HISTORIC AND DESIGN REVIEW COMMISSION

December 02, 2020

HDRC CASE NO: 2020-436
ADDRESS: 245 W WILDWOOD
LEGAL DESCRIPTION: NCB 9013 BLK 7 LOT 69 70 AND 71
ZONING: R-4, H
CITY COUNCIL DIST.: 1
DISTRICT: Olmos Park Terrace Historic District
APPLICANT: MCGOVERN TIMOTHY J & CHELSEA
OWNER: MCGOVERN TIMOTHY J & CHELSEA
TYPE OF WORK: Construction of a 2-story rear addition, fenestration modifications, exterior alterations
APPLICATION RECEIVED: September 29, 2020
60-DAY REVIEW: Not Applicable Due to City Council Emergency Orders
CASE MANAGER: Rachel Rettaliata
REQUEST:

REQUEST: Construction of a 2-story rear addition

FRONT ELEVATION comparison

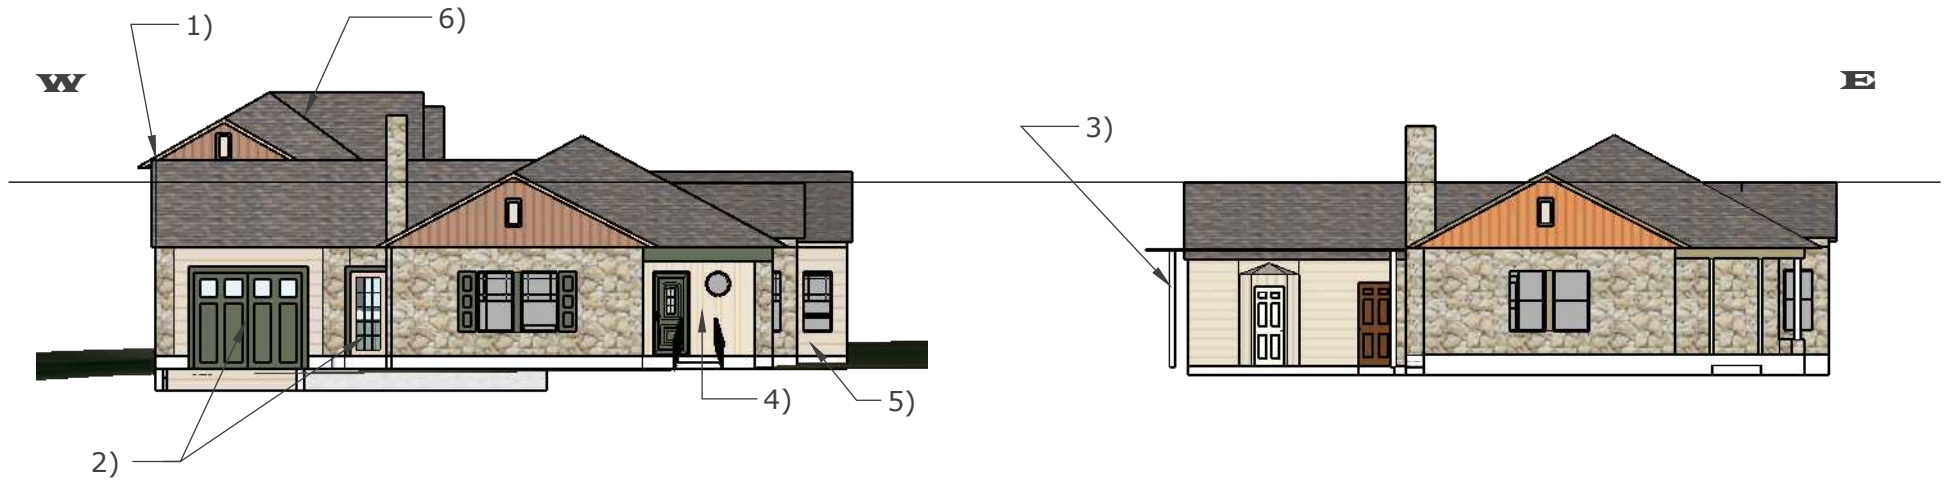
- k. GARAGE ROOF MODIFICATION – The applicant has proposed to raise the existing garage roof by one foot in order to have clearance for a 9-foot-high interior ceiling to match the existing ceiling height of the primary structure. Guideline 3.B.ii. for Exterior Maintenance and Alterations states that the original shape, line, pitch, and overhang of historic roofs should be preserved when replacement is necessary. Guideline 3.B.iv. for Exterior Maintenance and Alterations states that new roofing materials should match original materials in terms of their scale, color, texture, profile, and style. The proposal to raise the roof height appears to extend beyond the garage roof to the roof of the primary structure to the east of the existing chimney. Staff does not find the proposal appropriate.

- 1) Raise the garage roof by a foot in order to have clearance for a 9 foot interior ceiling like the original house.
- 2) Rebuild original garage doors and move the carport entrance to the right by 2 feet.
 - Replace the exterior door with a 15 pane door like the rest of the neighborhood
- 3) Remove metal carport. No replacement requested.
- 4) Convert the back half of the front porch into interior square footage. (approximately 8 feet)
 - Move the Front door location to facing the street.
 - Add a character enhancing circle window.
 - Add railings to hold onto when walking up the porch step.
 - Replace Stone columns in the corner of the porch like it was originally.
- 5) Add an extension on the East side replicating the same dimensions of the original.
- 6) Add a two-story addition to the back west side of the property--not to be added onto the original house structure.

Items 2, 3, 4, and 5, staff does not recommend approval based on findings k through n.

EAST ELEVATION comparison

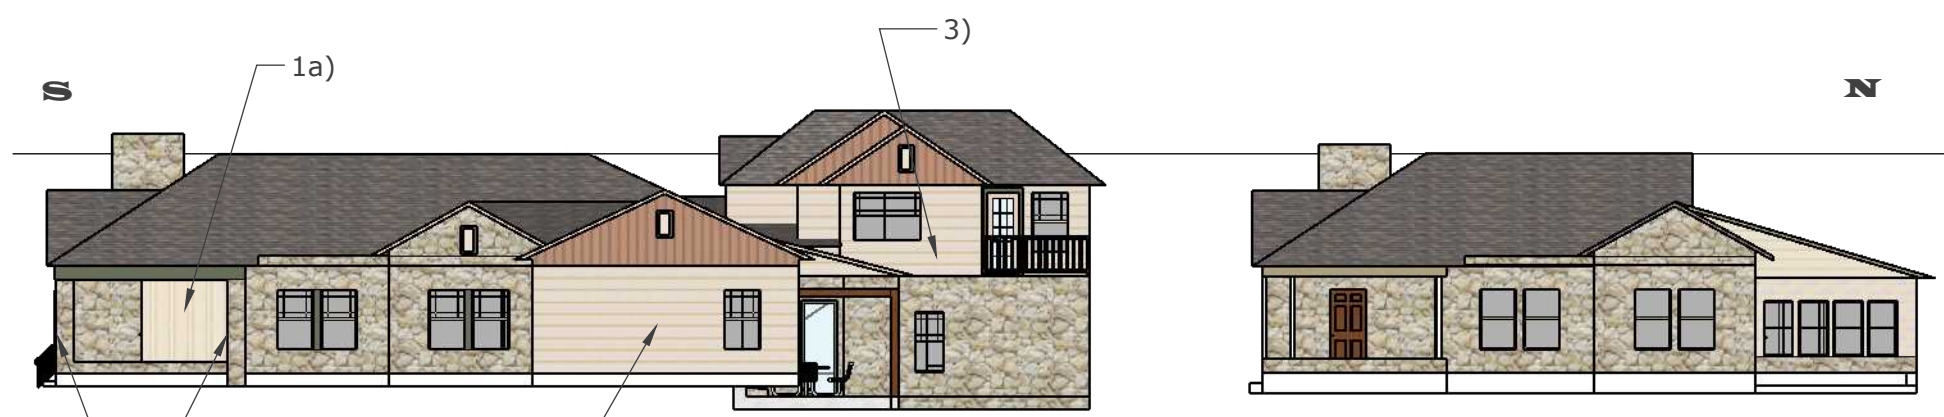
- l. FRONT PORCH ENCLOSURE – The applicant has proposed to partially enclose the existing front porch to convert to interior living space. The existing front porch appears to be in the original footprint as seen in the 1933 Sanborn Map. The applicant has provided precedent photos showing that front porches have been enclosed on other properties in the district. Guideline 7.A.i for Exterior Maintenance and Alterations states that existing porches should be preserved. According to Guideline 7.B.i for Exterior Maintenance and Alterations, applicants should refrain from enclosing front porches. Staff finds the proposal inconsistent with the Guidelines.

- m. FRONT DOOR RELOCATION – The applicant has proposed to relocate the front door opening from the west elevation of the front porch to face the street to the south. The front porch shows evidence of a previously existing opening facing south. Guideline 6.A.i for Exterior Maintenance and Alterations stipulates that existing window and door openings should be preserved. Avoid enlarging or diminishing to fit stock sizes or air conditioning units. Avoid filling in historic door or window openings. Avoid creating new primary entrances or window openings on the primary façade or where visible from the public right-of-way. The applicant has provided evidence that an opening facing south was previously existing, but it is not clear if that opening was previously a window or door opening. Staff finds that the evidence does not support enclosing the existing front door.

- 1) Rebuild front porch corner rock columns.
 - 1a) Convert the back half of the front porch into interior living space.
 - Front door faces street
- 2) Addition to the original house.
- 3) Semi detached addition with second story.

EAST ELEVATION comparison

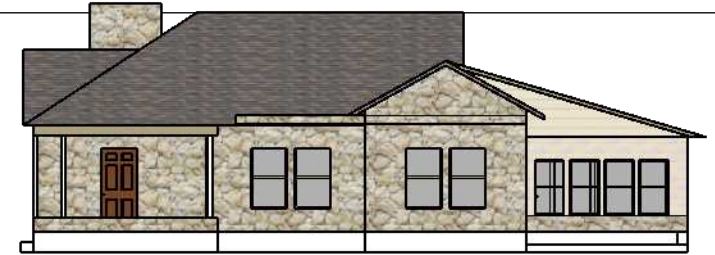
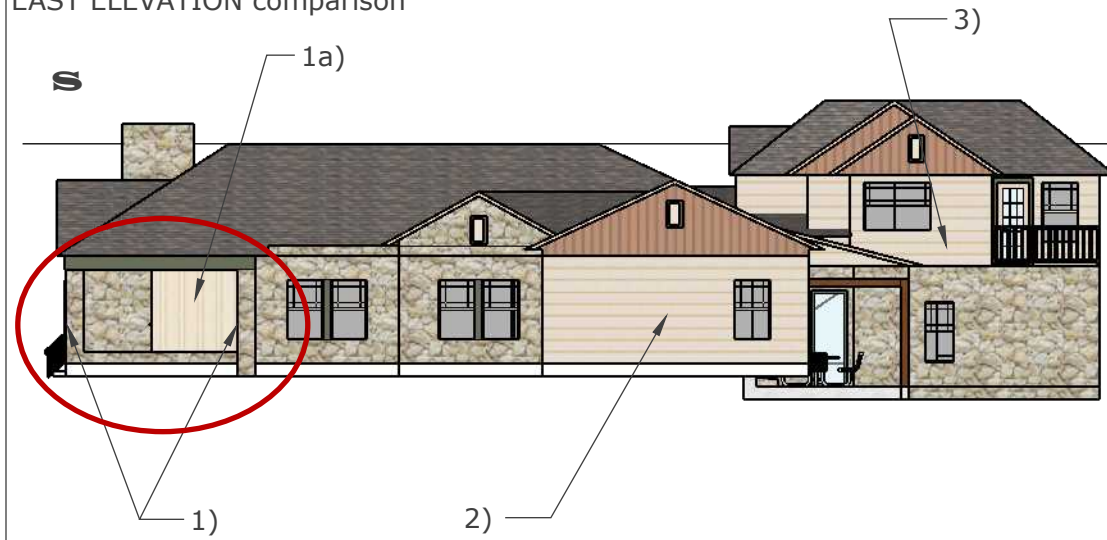
You can see the outline of the original door facing the street. I would like to make this the front door entrance.

Many homes have rocked in their original door that faces the street. I would like to convert half the porch and reinstate the door facing the street as my front door.
